CITY OF WORCESTER, MASSACHUSETTS

Subject: **Bid No. 7766-W2, Office Renovations – 50 Officer Manny Familia Way / DPF**

ADDENDUM NO. 3

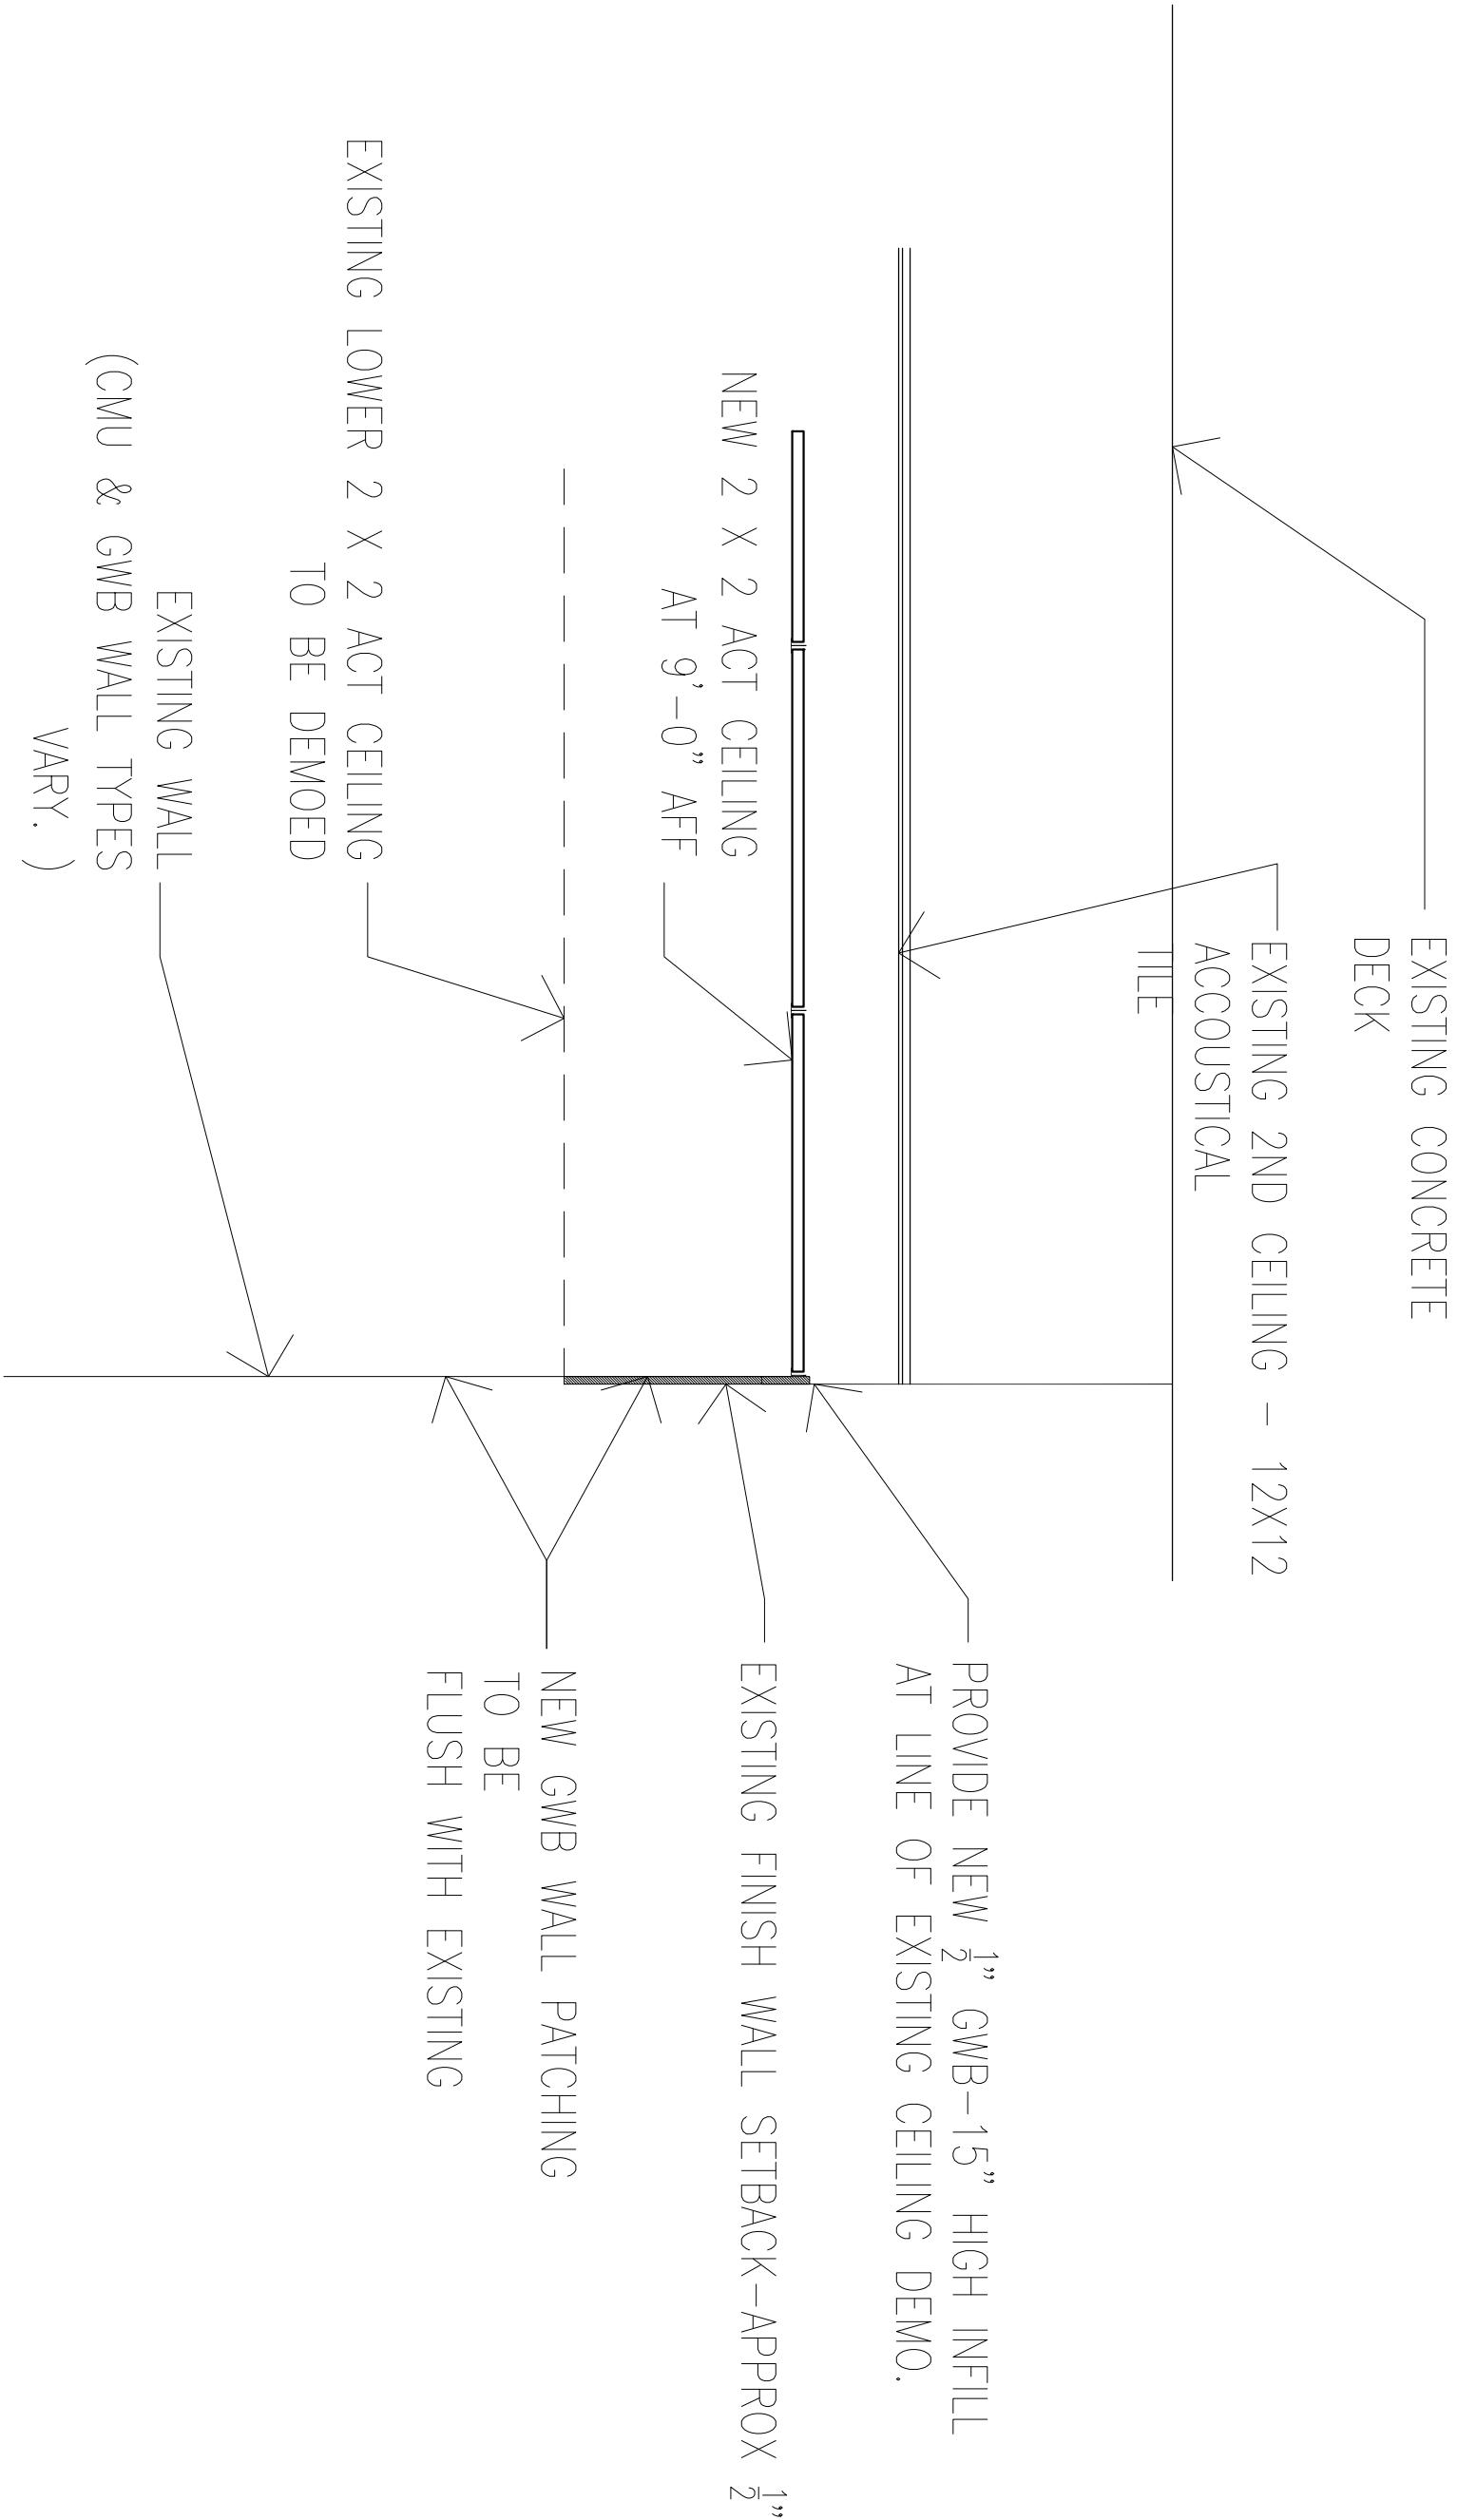
2. Question: Please provide a detail for the work at the top of the wall in the Conference room area.

Answer: *See attached sketch SKA-02 for Conference Room and Break Room detail.*
